6768B **County Permit Review Worksheet** 1385

IMPROVEMENT PERMIT for a RESIDENTIAL ON-SITE WASTEWATER TREATMENT & DISPOSAL SYSTEM

GWS Septic System Design Review

RE: Request for an Improvement Permit for Lot 30 off of Sample Road at The Retreat at Latta Plantation
MCHD File #6768B

Scale: 1 inch equals 50 feet	S&ME	Faison - The Retreat at Latta Plantation	FIGURE
Drawn by: JBP		Lot 30	
Reviewed by: TCJ		Mecklenburg County, NC	1
Date: May, 2007	ENVIRONMENTAL SERVICES · ENGINEERING · TESTING	S&ME Project #1588-05-091

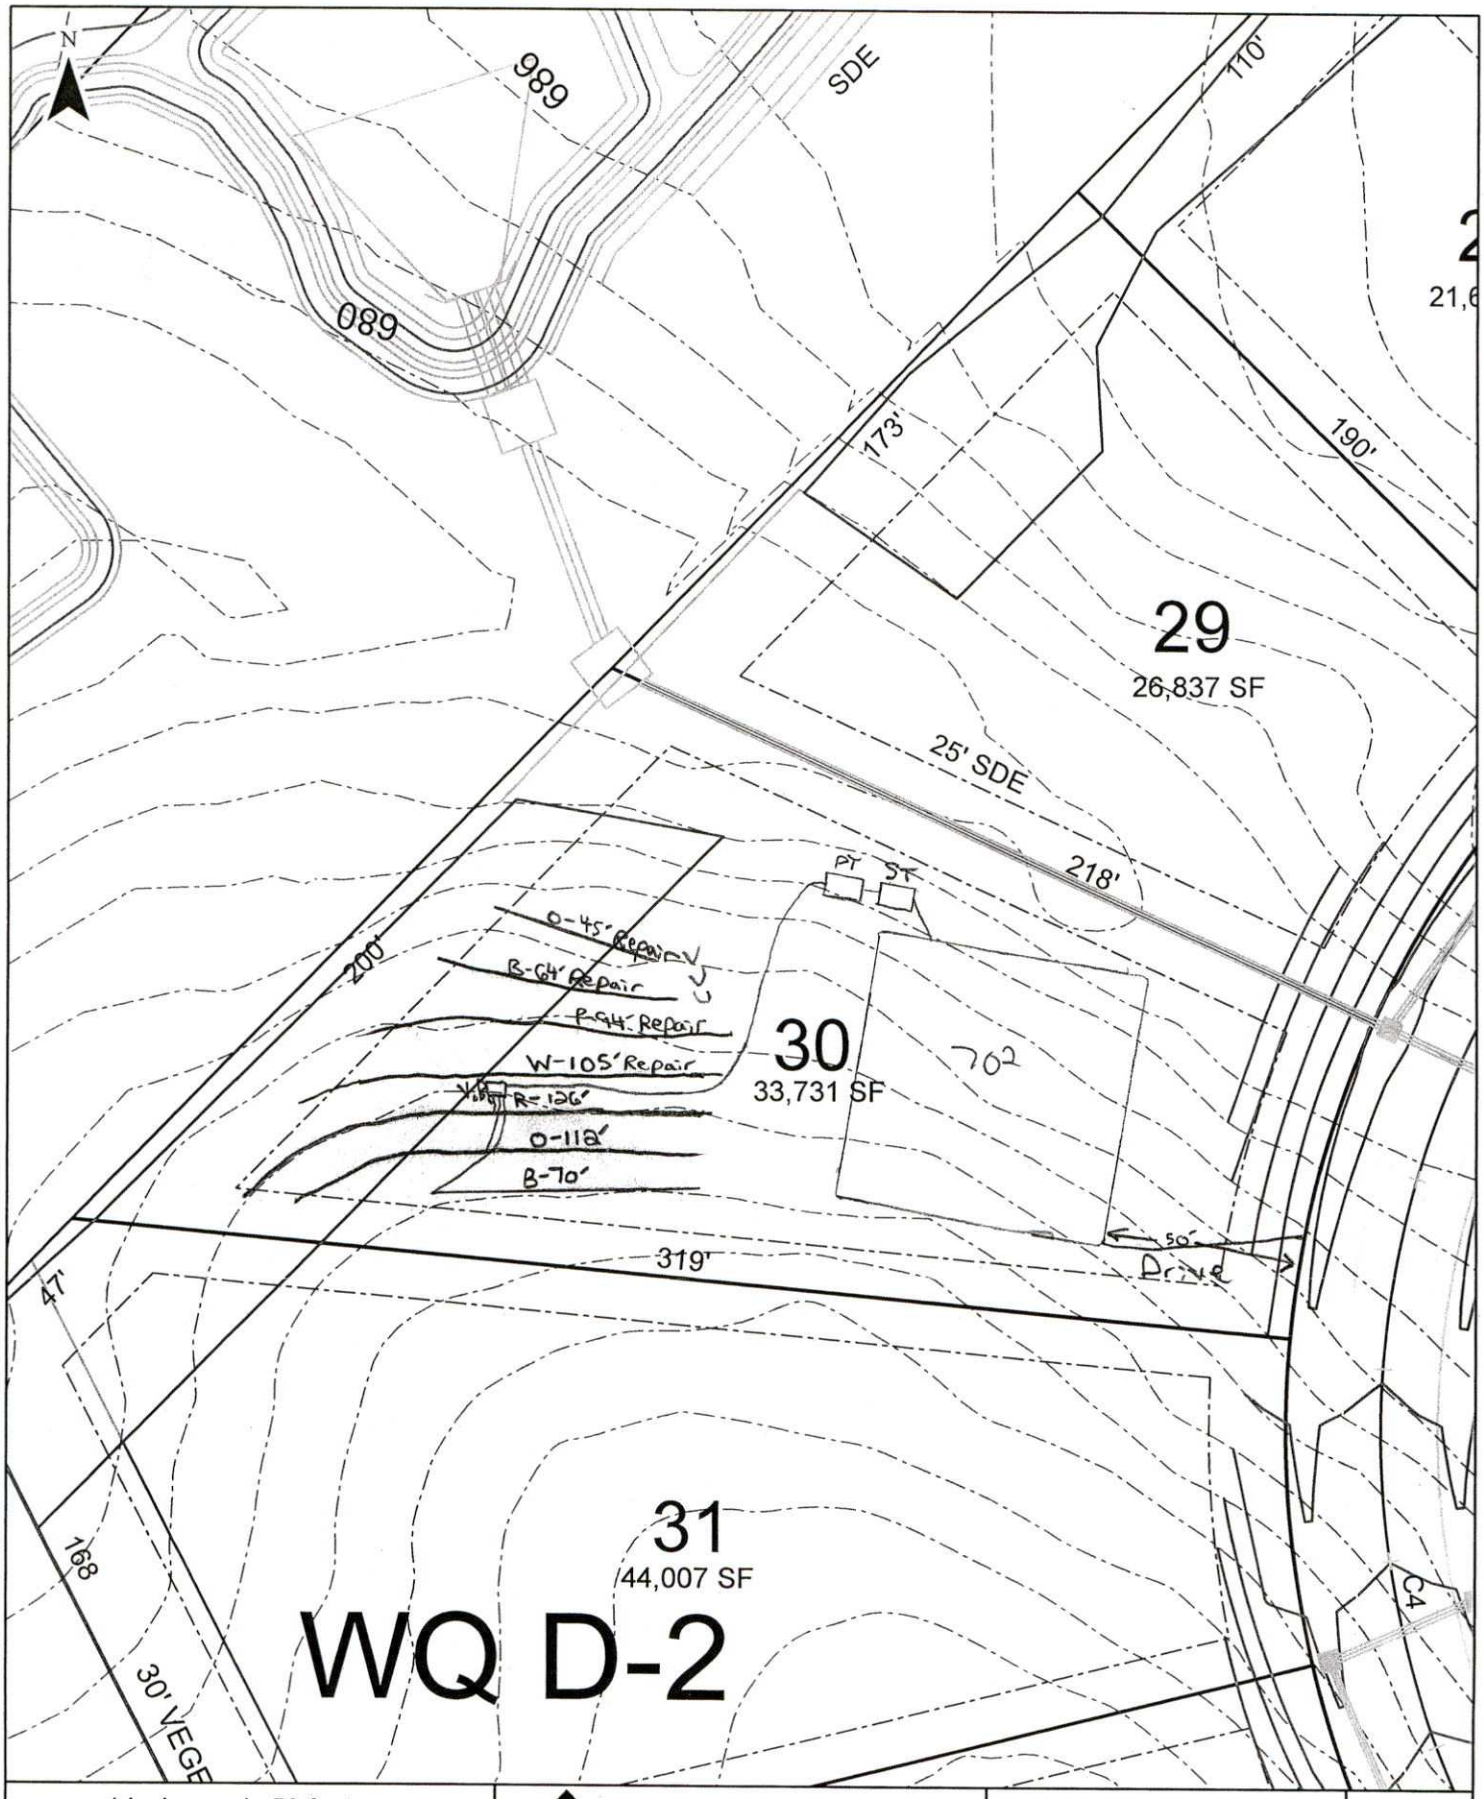
1. Need updated application on file for 5 bedrooms.
2. Update soil report to reflect 5 bedroom evaluation.
